# **i960<sup>®</sup> RP/RD I/O PROCESSOR SPECIFICATION UPDATE**

Release Date: June, 1998  
Order Number: 272918-019

The i960<sup>®</sup> RP/RD I/O Processor may contain design defects or errors known as errata which may cause the product to deviate from published specifications. Current characterized errata are documented in this Specification Update.

**Figure 1. DRAM RAS# Configurations**

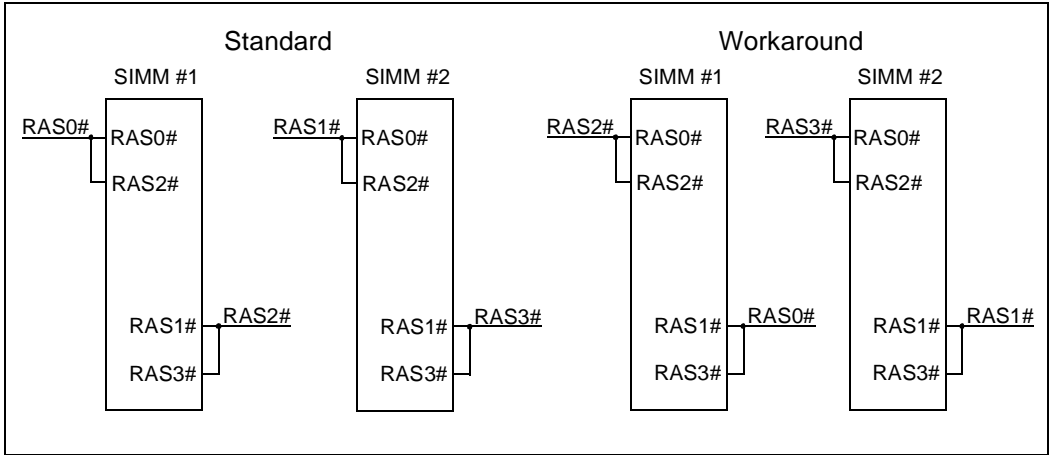
#### ***CASE 2 WORKAROUND - Initializing from 80960RP/RD DRAM instead of FLASH/ROM***

In a standard DRAM configuration, RAS0# and RAS1# are routed to the front sides of the SIMMs, and RAS2# and RAS3# are routed to the back sides of the SIMMs. To implement this workaround, swap RAS0# and RAS2# and swap RAS1# and RAS3#. This routes RAS2# and RAS3# to the front sides of their respective SIMMs, and routes RAS0# and RAS1# to the back sides of their respective SIMMs (See [Figure 1](#)). To determine which RAS# is asserted for a particular address and DRAM configuration, see [Table 1](#).

In an application using 4 Mbytes per bank/leaf and two single-sided SIMMs populated in a four bank design (total DRAM = 8 Mbytes), the following registers are set:

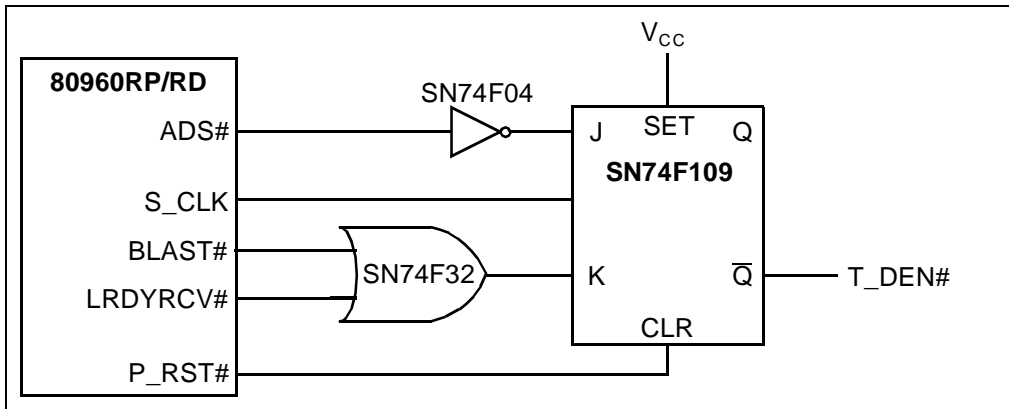
**ITEM:** When using an ICE in your 80960RP/RD system, the use of the Data Enable signal (DEN#) is not recommended. This clarification describes how DEN# operates and a recommended solution for using it with an In-Circuit Emulator (ICE).

**Using DEN# with an In-Circuit Emulator:** For ICE users, it is not recommended that you use the 80960RP/RD's DEN# signal directly to your transceivers. When executing an ICE microcode transaction, the expected behavior is that DEN# would remain de-asserted during the entire transaction. However, DEN# asserts as described above. If your design uses DEN# to enable transceivers, the transceivers will be enabled. This may result in bus contention.

**Figure 11-6. V<sub>CCPLL</sub> Lowpass Filter**

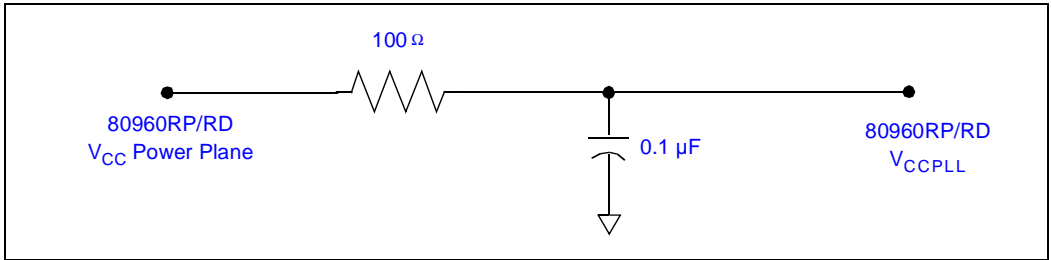
**5. Section 11.7.4, Page 11-27, Figure 11-6**

Replace Figure 11-6 with the following figure:

Figure 14-3. 32-Bit ROM or SRAM System

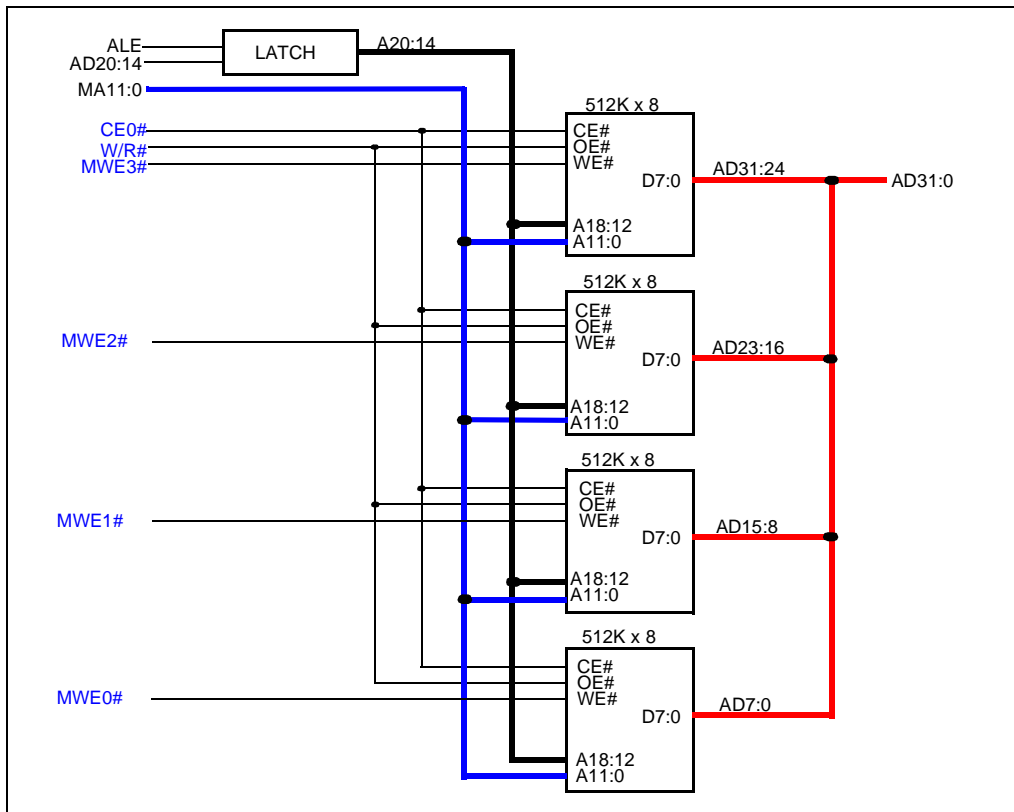
7. Section 14.4, Page 14-5, Figure 14-3

Figure 14-3 is incorrect. The correct figure is shown below:
